AMENDMENT TO THE DRAWINGS

ATTORNEY DOCKET NO.: 066476-0024
Application No.: 09/742,302
Reply to Office Action of Oct. 29, 2003
Replacement Sheet

FIG. 1

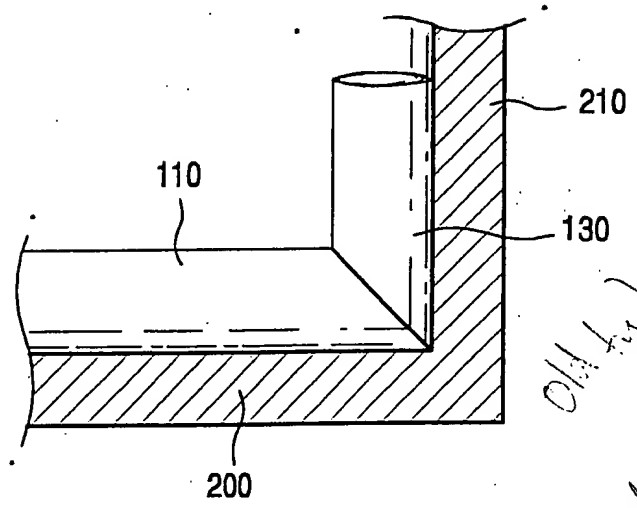
As required in the Office Action, Fig. 1 has been amended to disclose the open ends of the vertical pipes and a conventional dovetail joint which connects the horizontal and vertical pipes.
